**Response to
Reviewers Comments
on the Draft Cleanup Study Report
for the Duwamish Diagonal CSO/SD**

**Prepared for the
Elliott Bay/Duwamish Restoration Program Panel
by the
King County Department of Natural Resources and Parks**

April 2002

Draft 2001 Duwamish/Diagonal CSO/SD Cleanup Study Report

Figure 5-4

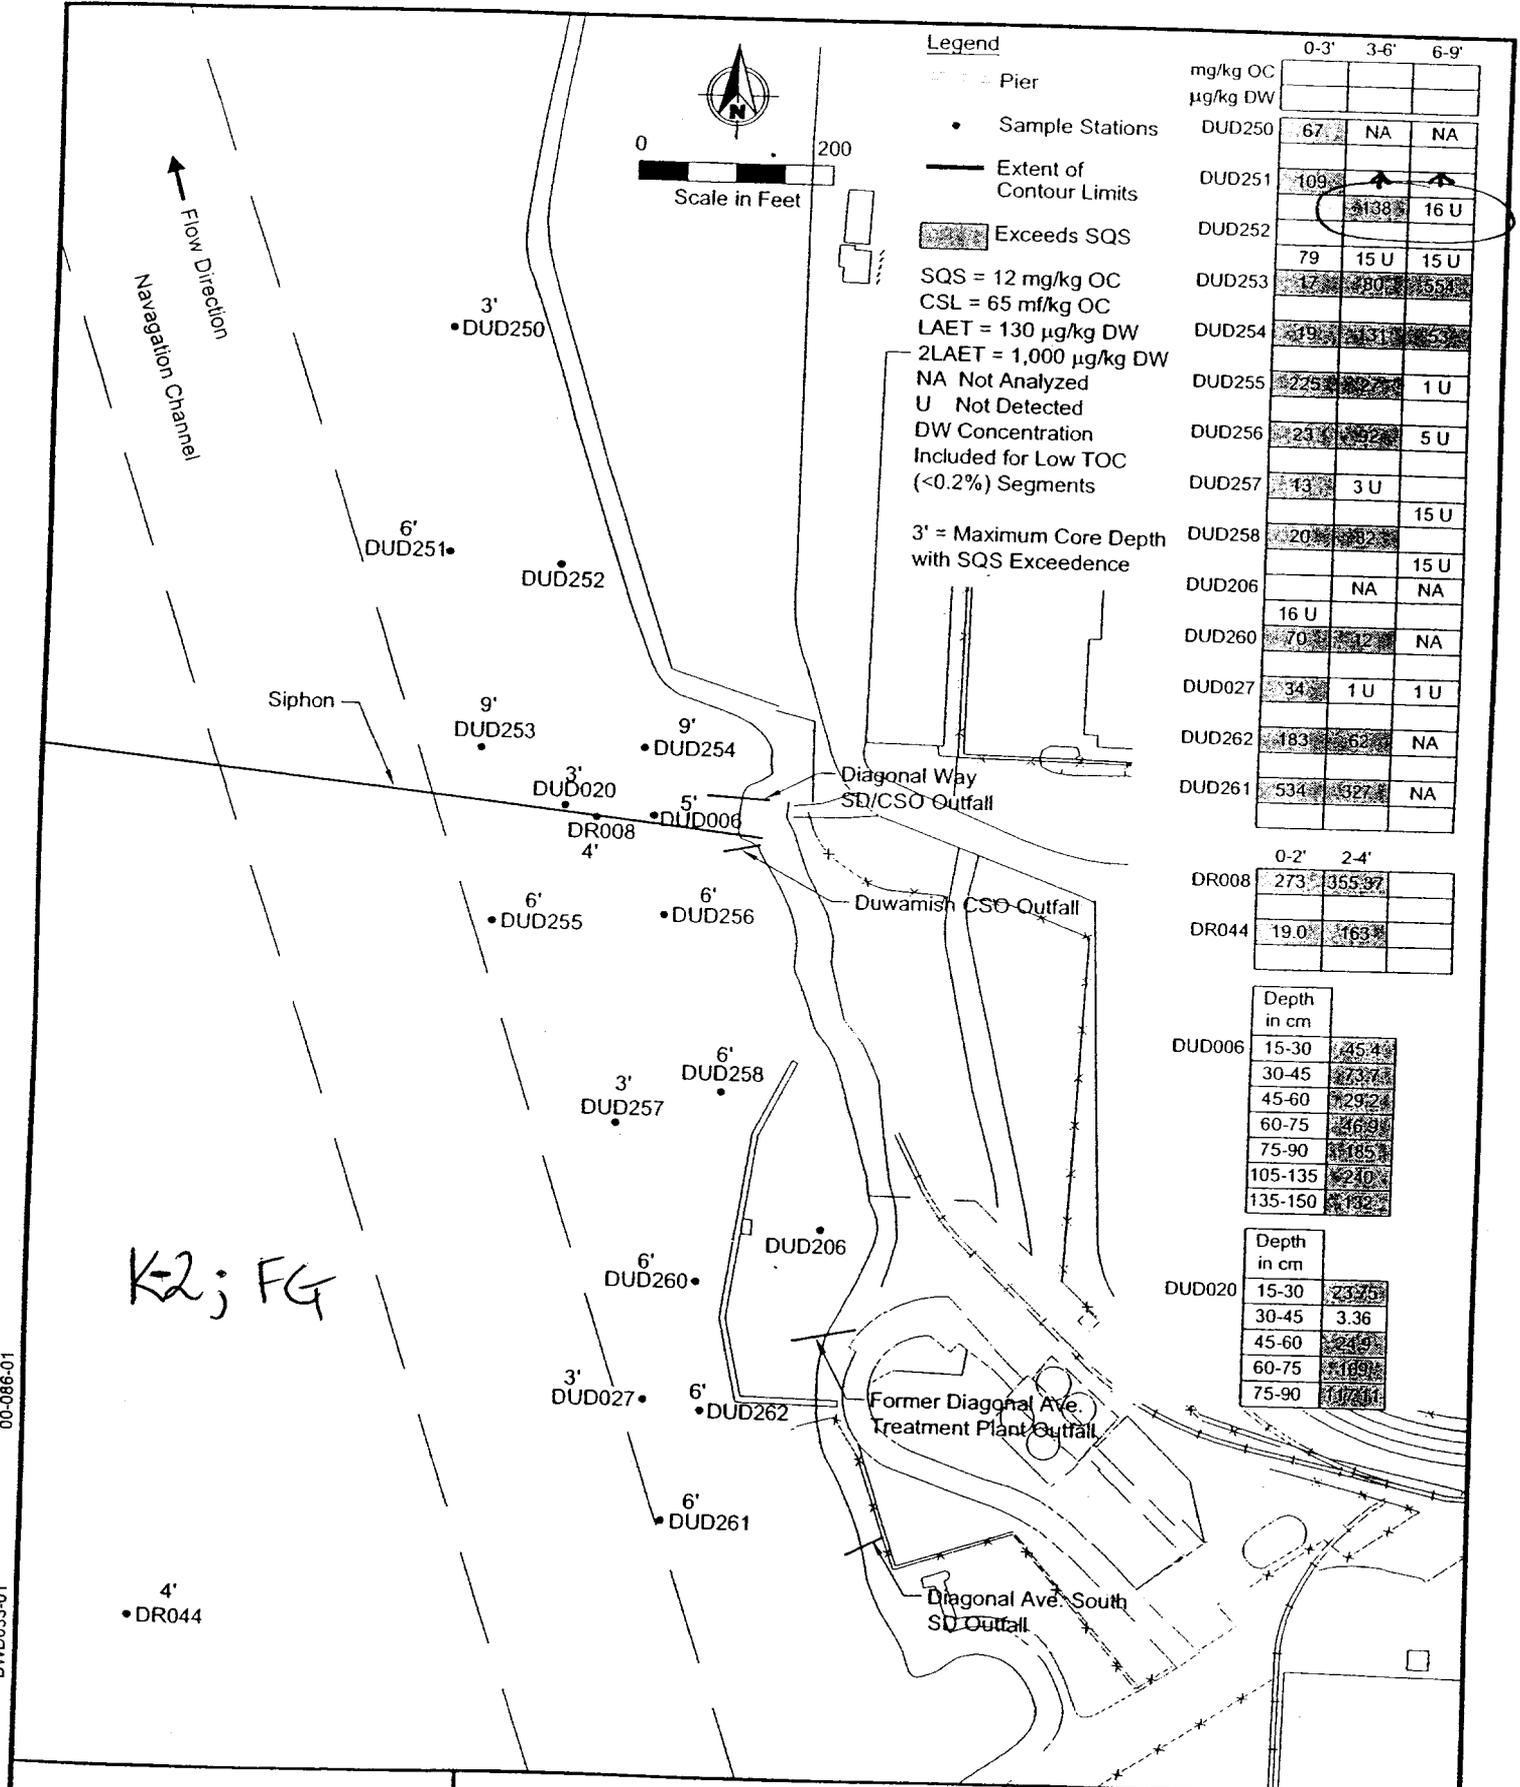
0-3'	3-6'	6-9'
mg/kg OC			
µg/kg DW			
DUD250	67	NA	NA
DUD251	109	138	16 U
DUD252	79	15 U	15 U
DUD253	17	80	6
DUD254	19	11	
DUD255	225		1 U
DUD256	23	2	5 U
DUD257	13	3 U	
DUD258	20	8	15 U
DUD206		NA	NA
DUD260	16 U	70	12
DUD260	70	12	NA
DUD027	34	1 U	1 U
DUD262	183	62	NA
DUD261	534	327	NA

- K-2; FG On Figure 5-4 and in the table to the right, the data for sample DUD251 needs to be moved into the correct row (i.e., the data is mg/kg OC). There may be some others that need to be moved as well.
